CITY OF SAINT PAUL  
HERITAGE PRESERVATION COMMISSION STAFF REPORT

FILE NAME: C & E Flats Housing Proposal  
 DATE OF APPLICATION: April 23 and 28, 2015  
 APPLICANT: Exeter Group LLC, Thomas Nelson  
 ARCHITECT: BKV Group, Inc., Mike Krych  
 OWNER: IAF 2400 University LLC  
 DATE OF PRE-APPLICATION REVIEW: May 14, 2015  
 HPC SITE/DISTRICT: University Raymond Commercial Heritage Preservation District  
 CATEGORY: Contributing  
 CLASSIFICATION: Rehabilitation/Addition/Alteration  
 STAFF INVESTIGATION AND REPORT: Amy Spong  
 DATE: April 28, 2015

A404  
© 2015 BKV Group, Inc. EOE

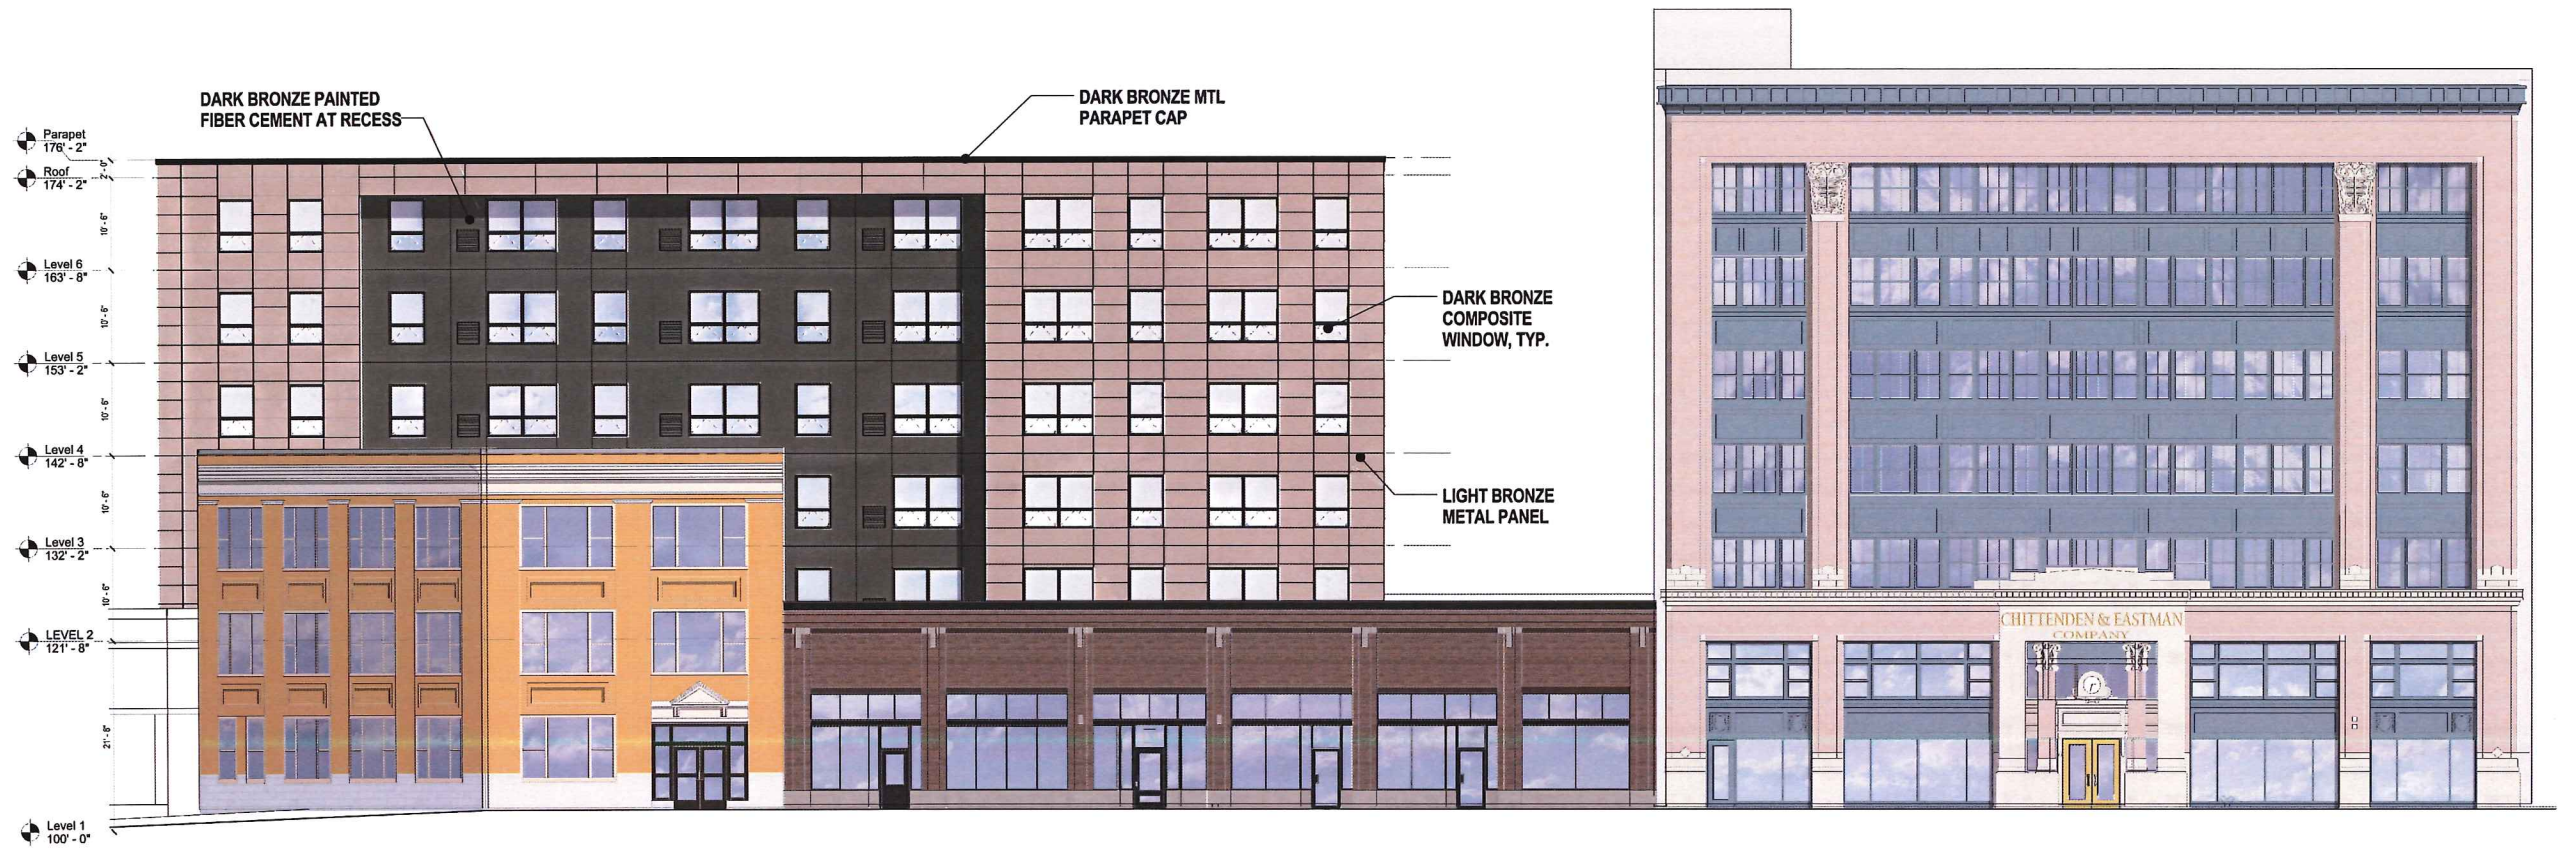
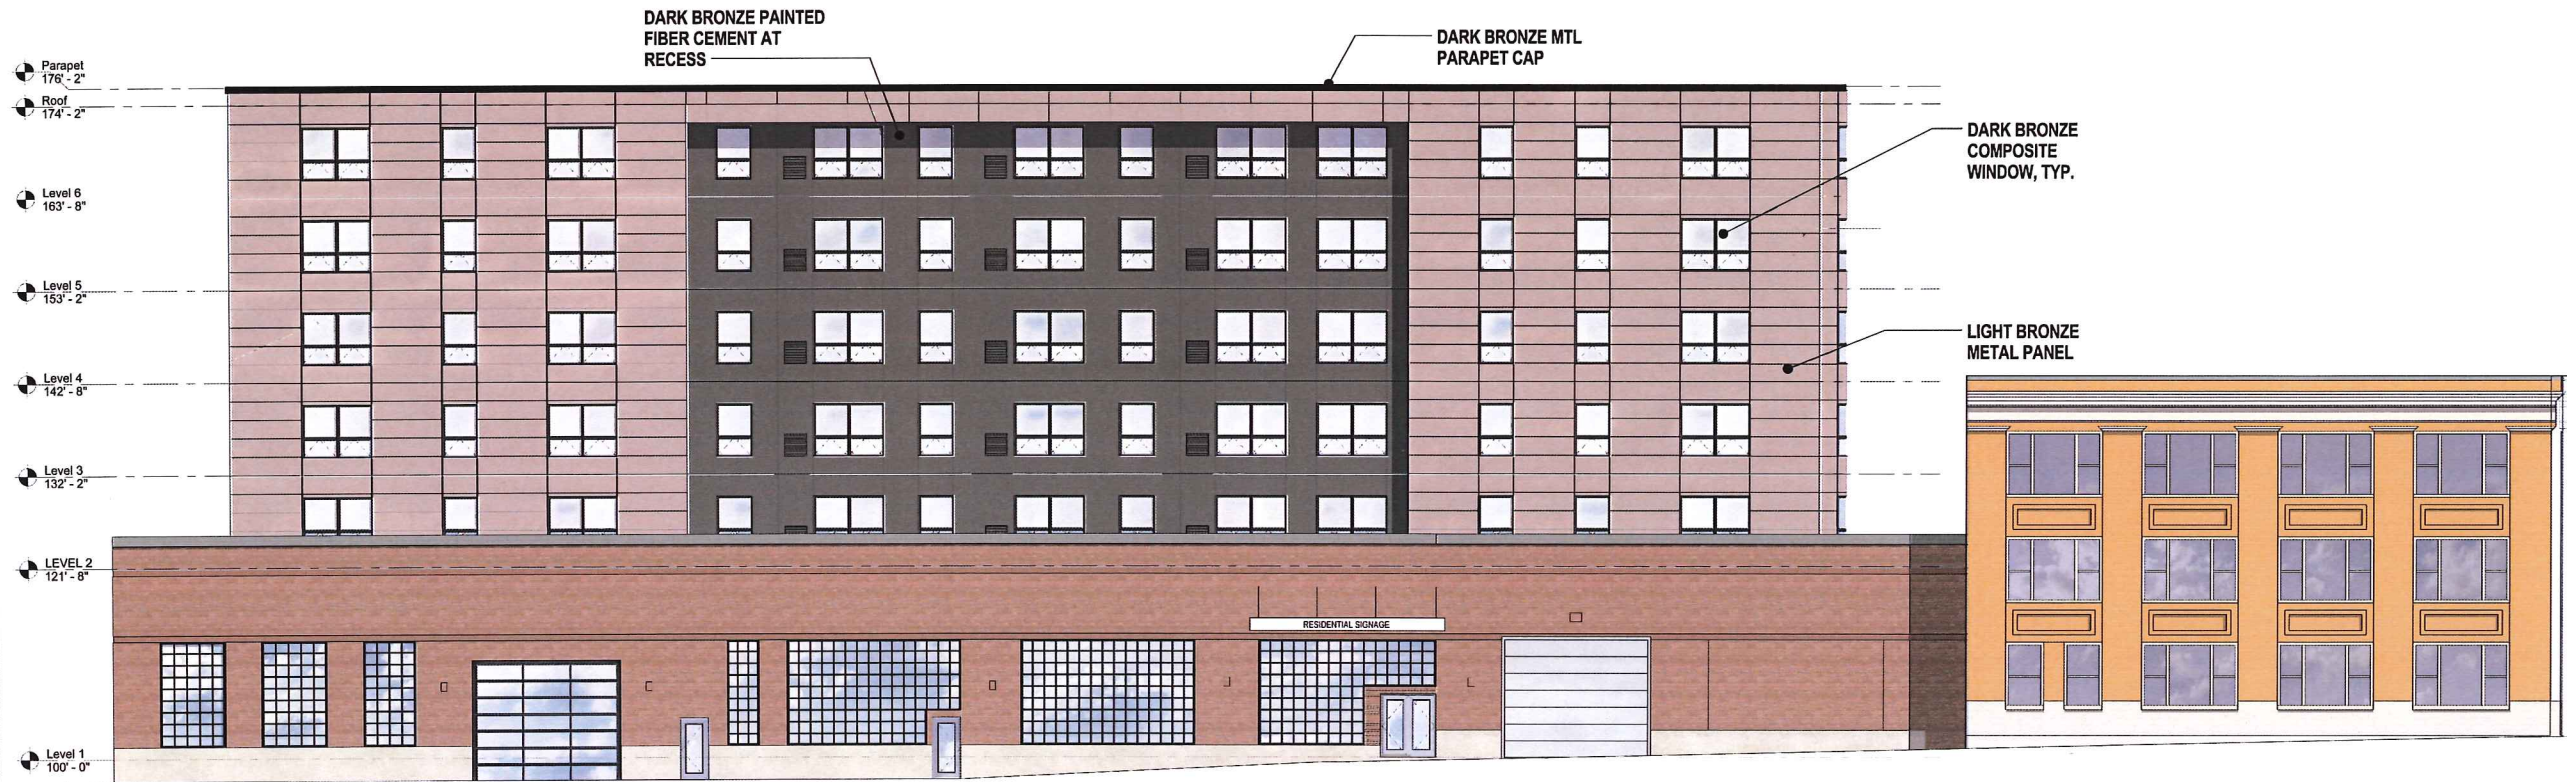
6. **74.06.3(e) New Construction.** The addition as viewed from University and Raymond Avenues does have a simple boxy profile which is an important element to maintain in this commercial district. A distinction must be made between free-standing new construction (infill) and appropriate additions to historic buildings. The Secretary of the Interior's Standards for Rehabilitation provide specific guidelines for additions and *Preservation Brief #14* further assists in reviewing rooftop additions to historic urban districts. The colors and stylized "recesses" recalls the pivotal C & E Building but the addition should relate more to the General Motor Truck Company Building its proposed to be attached to rather than the C & E. Even the name of the project references the C & E rather than recalling the unique history of the General Motor Truck Building.

7. **74.06.3(e)(1)(a) Setback.** The Standards recommend *designing additional stories, when required for the new use that are set back from the wall plane and are as inconspicuous as possible when viewed from the street.* The addition is set back from the wall plane but is not

**74.06.3(e)(1)(b) Massing, Volume, Height.** The proposal does not comply with guidelines for massing, volume and height as the rooftop addition will *result in the diminution or loss of the historic character of the resource, including its design, materials, workmanship, location, and setting.* The addition will add *additional stories so that the historic appearance of the building is radically changed.* The new addition is designed so that *its size and scale in relation to the historic building are out of proportion, thus diminishing the historic character.* A Conditional Use Permit (CUP) will also be required for height and reviewed and approved by the Planning Commission.

The boxy massing which is *the most essential element for maintaining district unity* will be diminished for the General Motor Truck Building and the nearby historic buildings: Twin Cities State Bank and the C & E Building. An aspect of the boxy character is that the historic buildings maintain their overall height or step down at the back. The addition will “step up” at the back of the building. There are several other contributing one and two story buildings in the Historic District and if additional stories are incrementally added over time, this may result in an overall diminishing character of the District.
